UNITED STATES PATENT AND TRADEMARK OFFICE

APPLICATION NO.	FILING DATE	FIRST NAMED INVENTOR	ATTORNEY DOCKET NO.	CONFIRMATION NO.
09/754,323	01/05/2001	Masatoshi Akagawa	1081.1102	3680
21171	7590	10/13/2004		
STAAS & HALSEY LLP SUITE 700 1201 NEW YORK AVENUE, N.W. WASHINGTON, DC 20005			EXAMINER NGUYEN, KHIEM D	
			ART UNIT 2823	PAPER NUMBER

Office Action Summary

DETAILED ACTION

Fig. 1

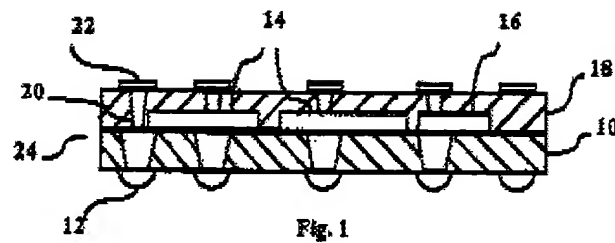
In re claim 18, Lauder discloses a semiconductor device comprising: a substrate **10** having a main surface; plural device layers stacked, in succession, on the main surface of the substrate, each device layer comprising: a conductive layer **22** comprising a wiring pattern (col. 3, lines 19-32); a semiconductor element **14** electrically connected to the wiring patterns **22** (col. 3, lines 26-40); and a single insulating layer **18** respectively associated with and embedding therein the semiconductor element **14** and the respective conductor layer **22** having conductive vias **20** extending therethrough (col. 3, lines 19-25), and the wiring pattern of the conductive layer **22** of each successive, stacked device layer being formed on an upper main surface of the single insulating layer **18** of the respective, underlying device and respective wiring patterns of the conductive layers **22** of the plural stacked device layers being selectively electrically interconnected through the corresponding vias **20** of the respective, single insulating layers **18** of the stacked, plural device layers **30, 32** (col. 2, line 64 to col. 3, line 46 and **FIGS. 1-2**).

In re claim 19, **Lauder** discloses wherein: the semiconductor elements 14 are commonly disposed within the respective insulating layers 18 and aligned in the plural, stacked device layers 30, 32 (FIGS. 1-2).

In re claim 20, **Lauder** discloses wherein the semiconductor device according to claim 18, further comprising: plural semiconductor elements 14 in each of the plural device layers and commonly disposed therein so as to be in aligned relationship in the stacked layers 30, 32 (FIGS. 1-2).

In re claim 21, **Lauder** discloses wherein the semiconductor device according to claim 18, wherein each insulating layer 18 surrounds and covers “substantially” all of each outer surface of the semiconductor element 14 embedded therein (FIGS. 1-2).

Applicant contends that as in the structure 24 of Fig. 1 of Lauder there is no “first conductive layer, comprising a first wiring pattern, embedded within the first insulating layer...” as recited in claim 14.

Independent claim 18 only recited the claimed limitation of having “a single insulating layer respectively associated with and embedding therein the semiconductor element” and does not required having a first conductive layer, comprising a first wiring pattern, embedded within the first insulating layer. Lauder as disclosed in FIGS. 1-2, providing an insulating layer 18 respectively associated with and embedding therein the semiconductor element 14. Thus, Lauder teaches the claimed limitations as recited in independent claim 18. For these reasons, examiner holds the rejection proper.
